1st Further Information

**Proposed Temporary Place of Recreation, Sports or Culture with Ancillary Facilities
for a Period of 3 Years and Associated Filling of Land in "Agriculture" Zone,
Lots 110 S.A RP, 110 S.B, 110 S.C, 110 S.D ss.1 S.A, 110 S.D ss. 1 RP, 110 S.D ss.2, 110 S.D ss.3
and 110 S.D RP in D.D. 112, Shek Kong, Yuen Long, New Territories**

(S.16 Planning Application No. A/YL-SK/400)

Response-to-Comment

DWG. TITLE SWEPT PATH ANALYSIS

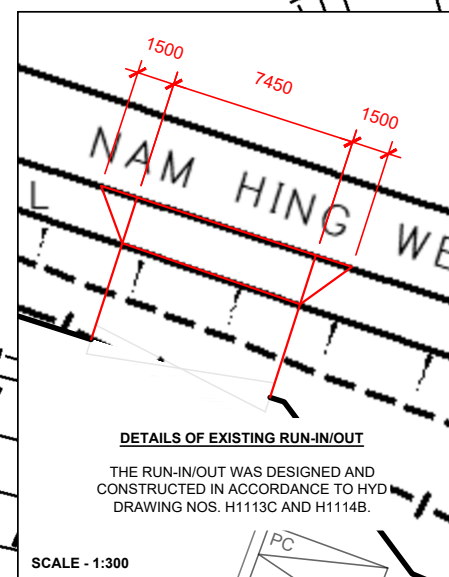
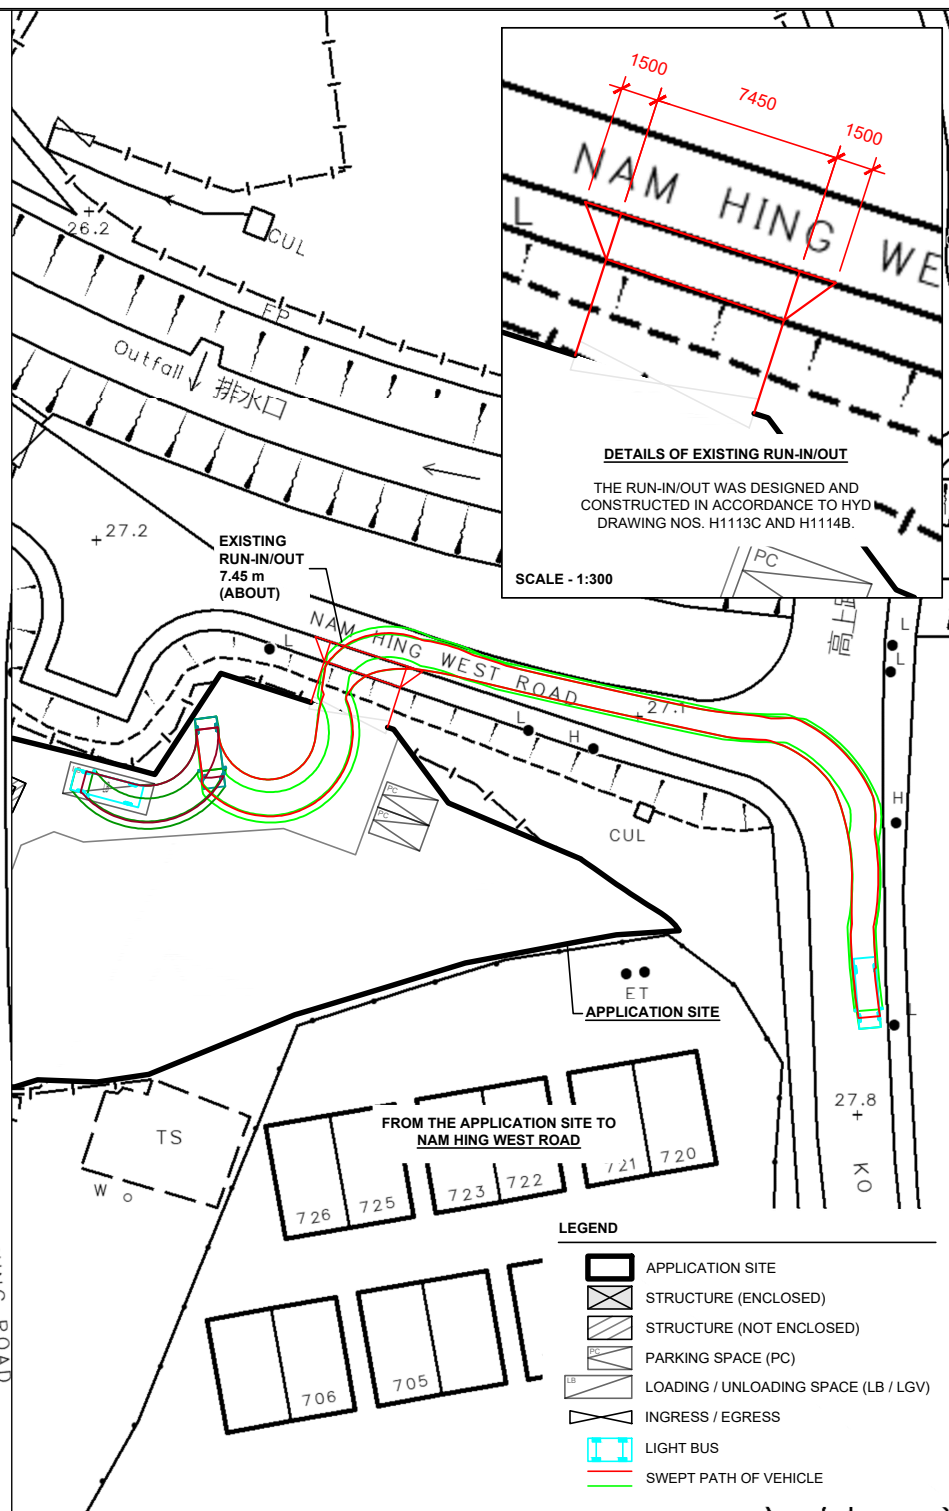
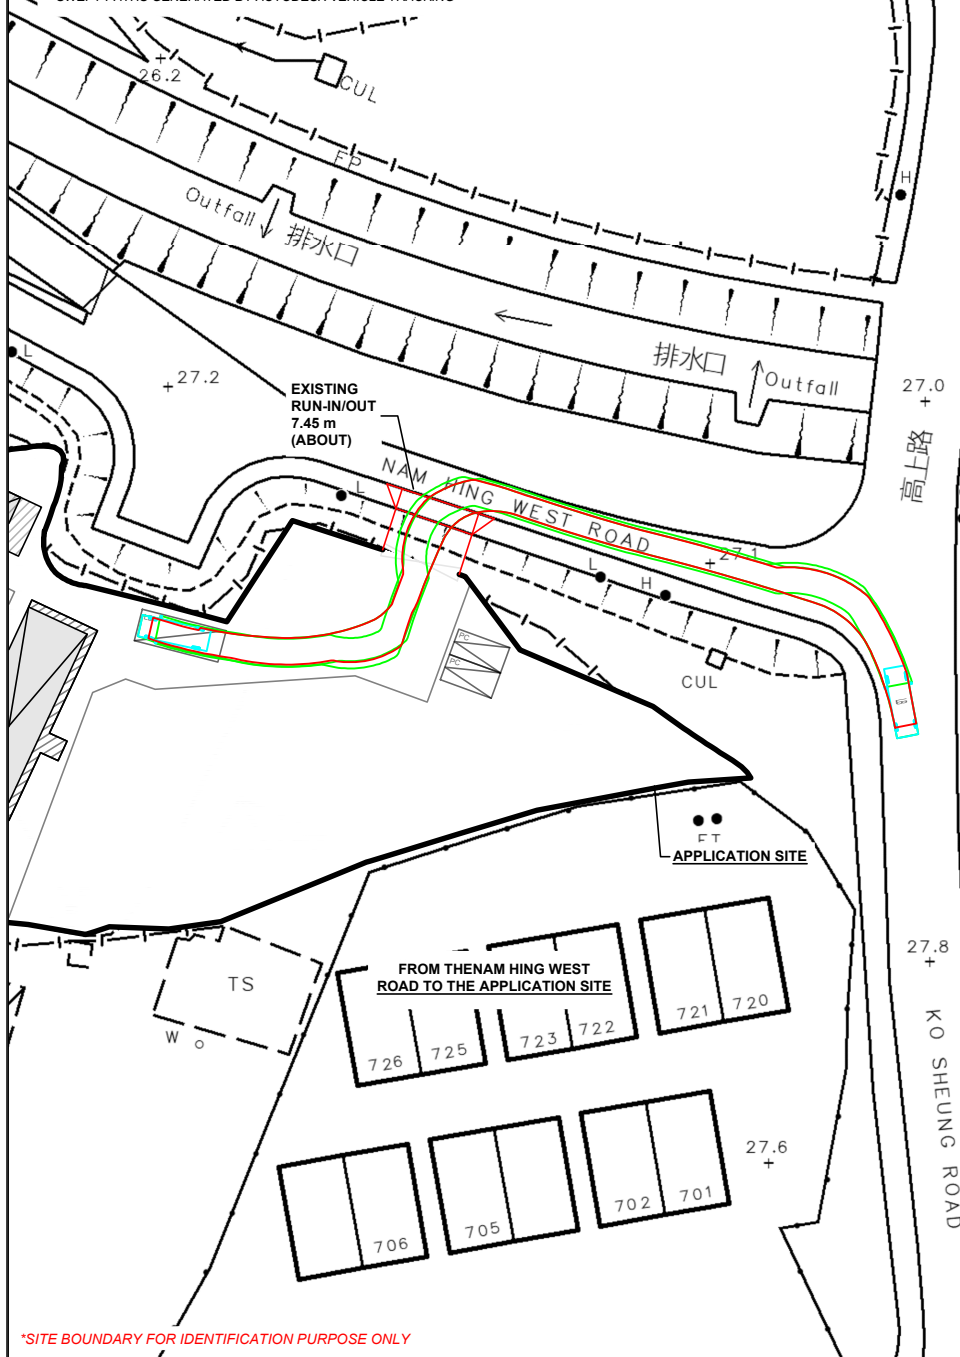
- (iii) In order to reflect the revised dimension in the run-in/out proposal, the applicant has submitted the revised layout plan and swept path analysis to rectify the width of the ingress/egress of the application site. The revised plans are enclosed at **Annex 4**.
